T-SB-0037-12

February 15, 2012

Smart Key Inoperative

Figure 2.

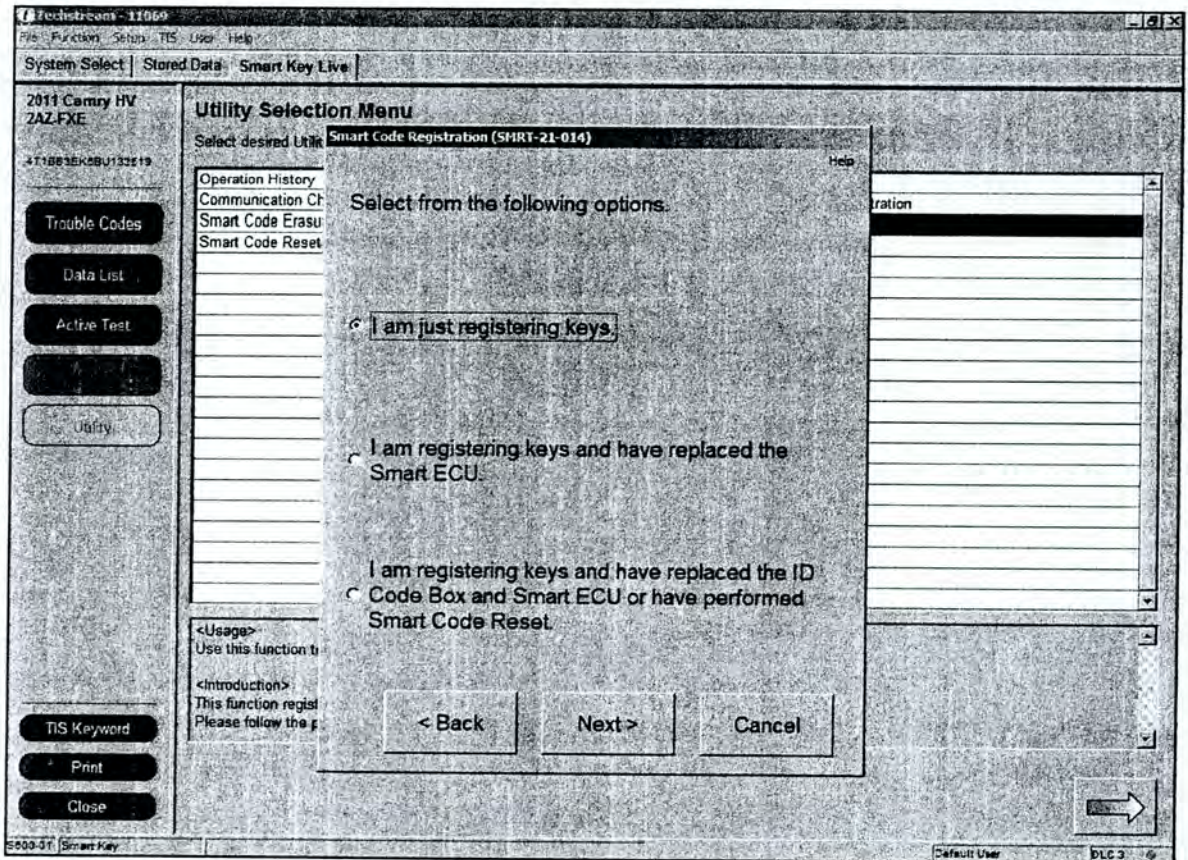
- B. Authorize addition of FM key by first placing original AM key (FCC: -AB) on start button for one beep.
- C. Add one new FM key by placing it above start button for first beep, and on seat for second beep.
- D. Close Smart Code Registration utility to complete step 1.
- E. Remove all original AM keys from your work area. They are no longer needed.
